Subject: Klamath Facilities Removal - Final Environmental Impact Statement / Environmental Impact Report, Sept 2011 (EIS/EIR) - Comments.

Subject: Klamath Facilities Removal - Final Environmental Impact Statement / Environmental Impact Report, Sept 2011 (EIS/EIR) - Additional Comments.

Subject: Klamath Facilities Removal - Final Environmental Impact Statement /
Environmental Impact Report, Sept 2011 (EIS/EIR) - Comments.

The earth dam's Cross Section - Iron Gate's Elevations are shown.

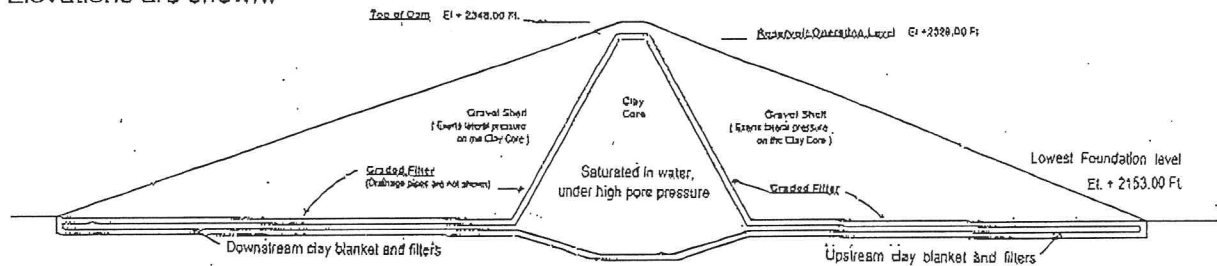
1.0. The Scientific Proof: Below is an earth dam's general cross section. Iron Gate's Elevations are shown.

The earth dams have three sections.

- An inner "Clay Core" to prevent reservoir water from leaking through.
- "Filters" on both sides of the "Clay Core." They prevent clay particles from escaping. They also safely confine the clay below the weight of the dry earth on top.
- An outer "Gravel shell" that exerts lateral pressure on (*in other words, squeezes*) the wet "Clay Core." The "Gravel shell" gives stability to the dam.

1.1. During dam construction, the clay is compacted "stone hard" with low moisture content, to resist the Gravel shell's pressure. Below are a few characteristics of clay.

The earth dam's Cross Section during breaching.

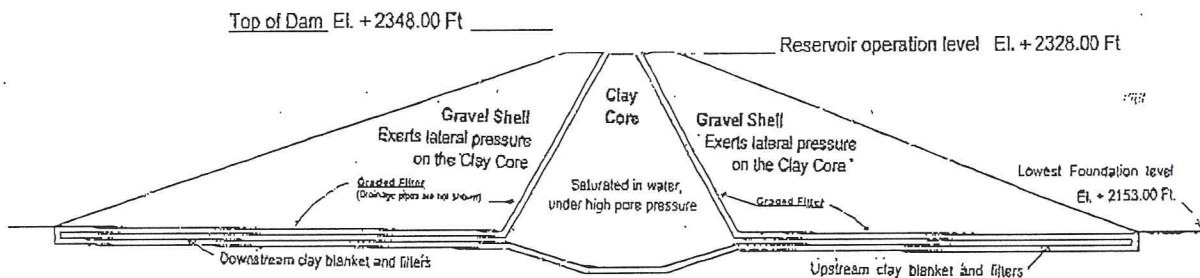
1.4. Prior to breaching, the wet clay core is "confined". It is designed to resist the Gravel shell's pressure and the dam is safe.

1.5. During the "proposed action" to remove the Iron Gate and J.C. Boyle earth dams, the wet clay core will become "unconfined." It will yield to the Gravel shell's pressure and the dam will collapse catastrophically.

1.6. Consequences of catastrophic collapse. The lives of machinery operators on the dams' top and of people below, will be in peril. Expensive models could predict the debris' shape after the collapse. The debris will envelope the diversion tunnel's "inlet" and "outlet". The reservoir levels will rebuild. Water will pressure its way through and over the collapsed debris. Expensive overhead cable ways will be hastily required to remove the debris, bucket by bucket. The future of Salmon will be adversely impacted.
